Correction of errors in the proposal for the 01 series of amendments to UN Regulation No. 148 (Light-signalling devices)

The text reproduced below was prepared by the GRE Informal Working Group on Simplification of Lighting and Light-Signalling Regulations (IWG SLR) with the aim to correct some errors identified in the proposal for the 01 series of amendments to UN Regulation No. 148 (doc. ECE/TRANS/WP.29/GRE/2021/13).

Figures A2-III

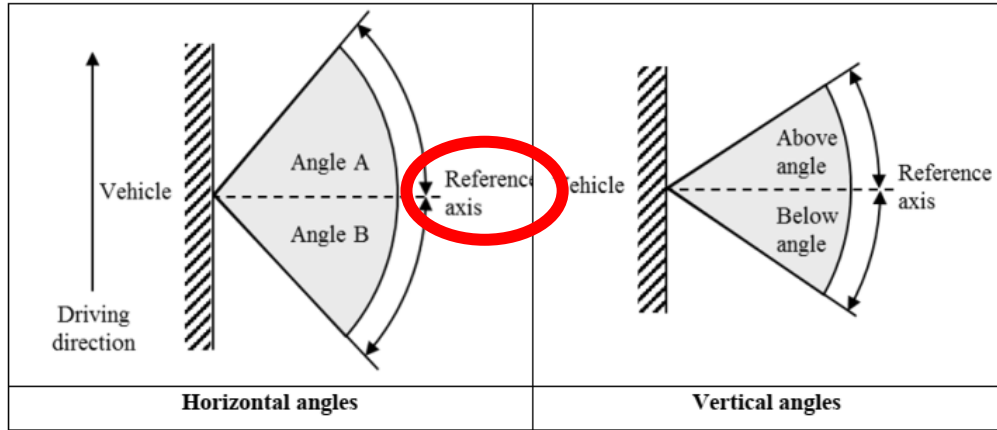
Figure A2-III, reduce the size of the figure on the left “Horizontal angles” in order to read the text properly

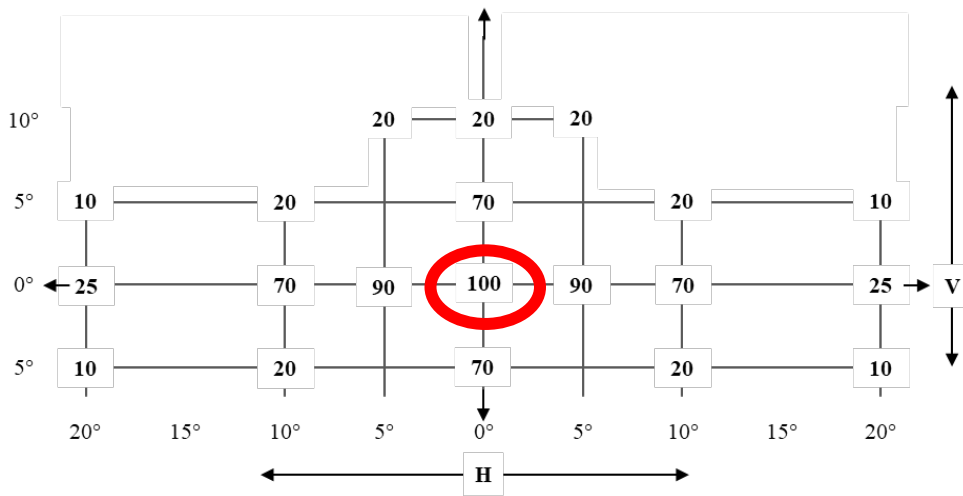
Figure A3-II, correct figure to read the full values in the boxes

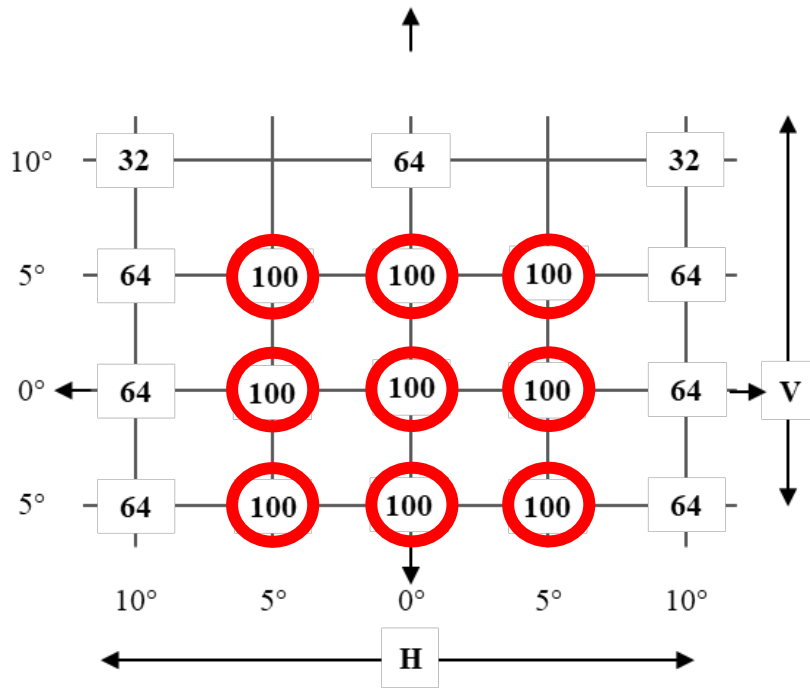
Figure A3-III, correct figure to read the full values in the boxes

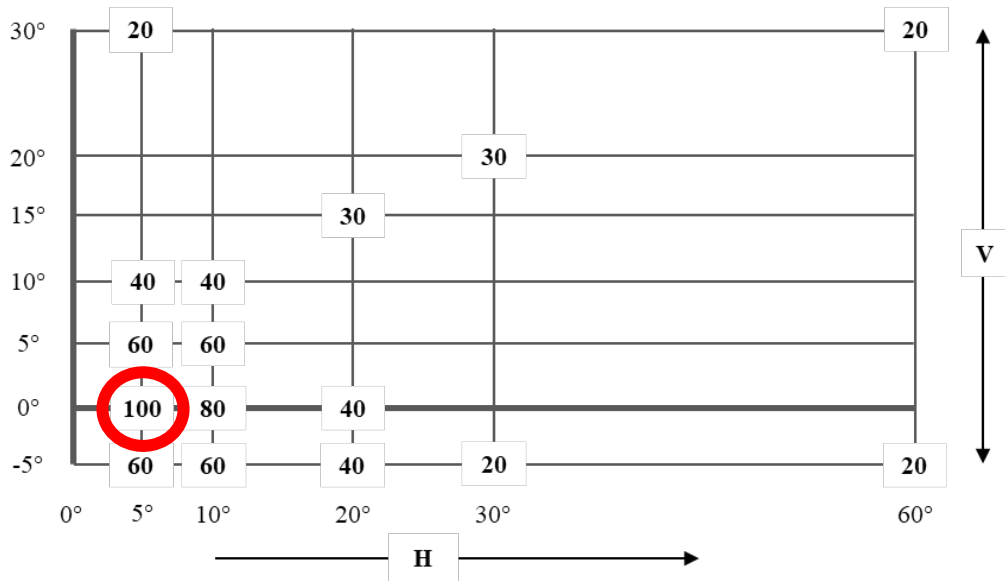
Figure A3-IV, correct figure to read the full values in the boxes

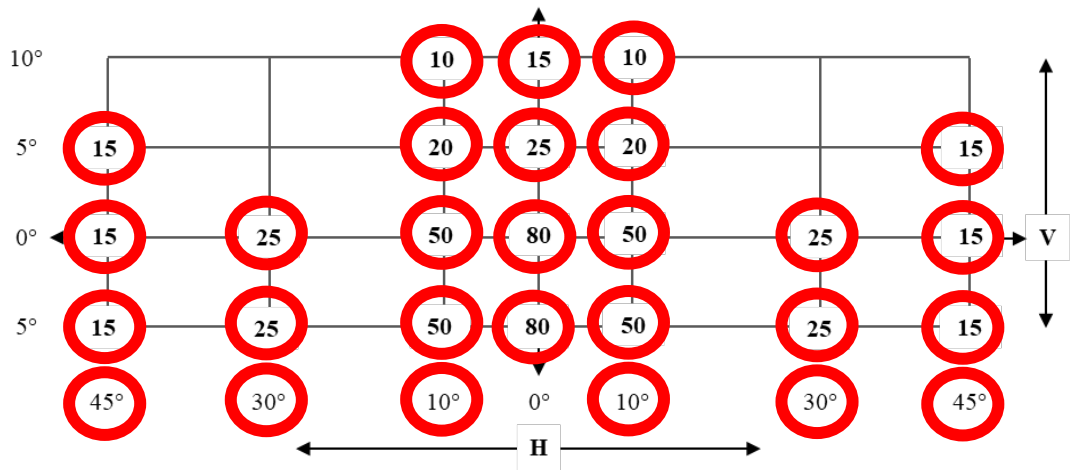
Figure A3-V, correct to read the full values in the boxes and add the “°” sign

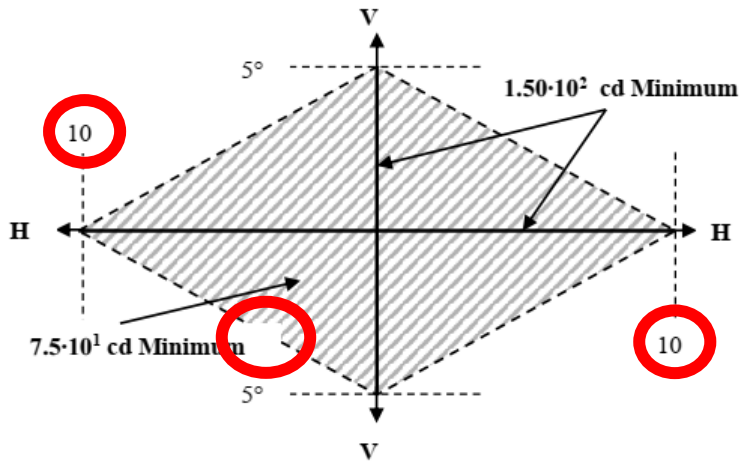
Figure A3-VI, correct to remove white corner and add the “°” sign

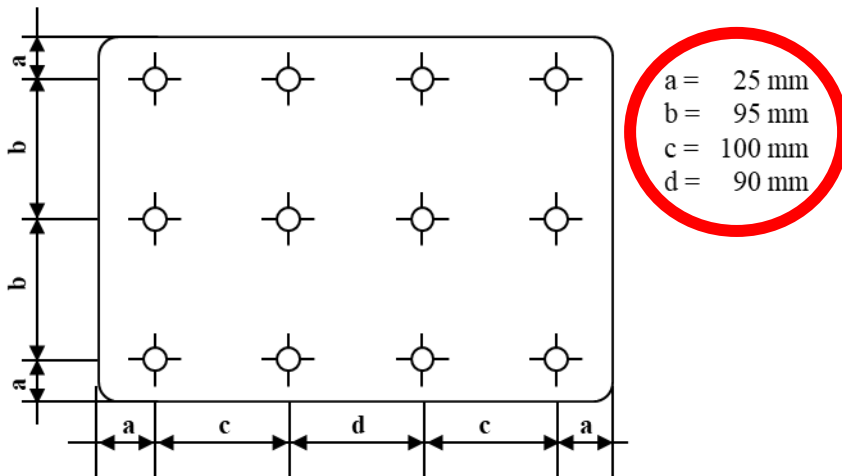
Figure A3-IX, correct figure to read the full values in the legend

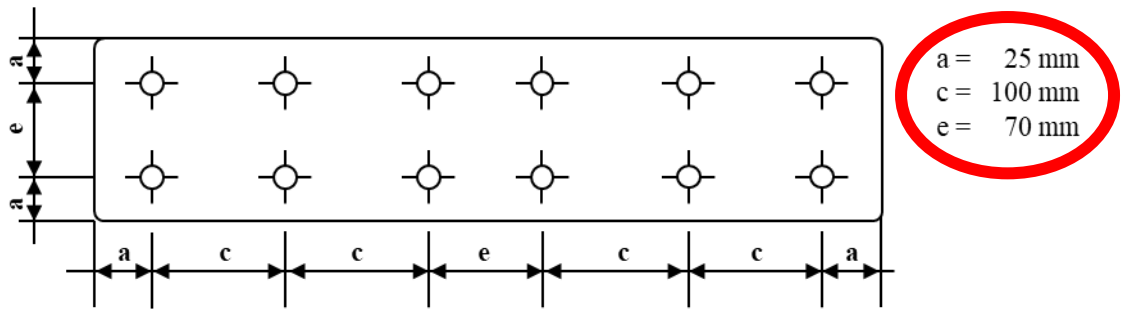
Figure A3-X, correct figure to read the full values in the legend
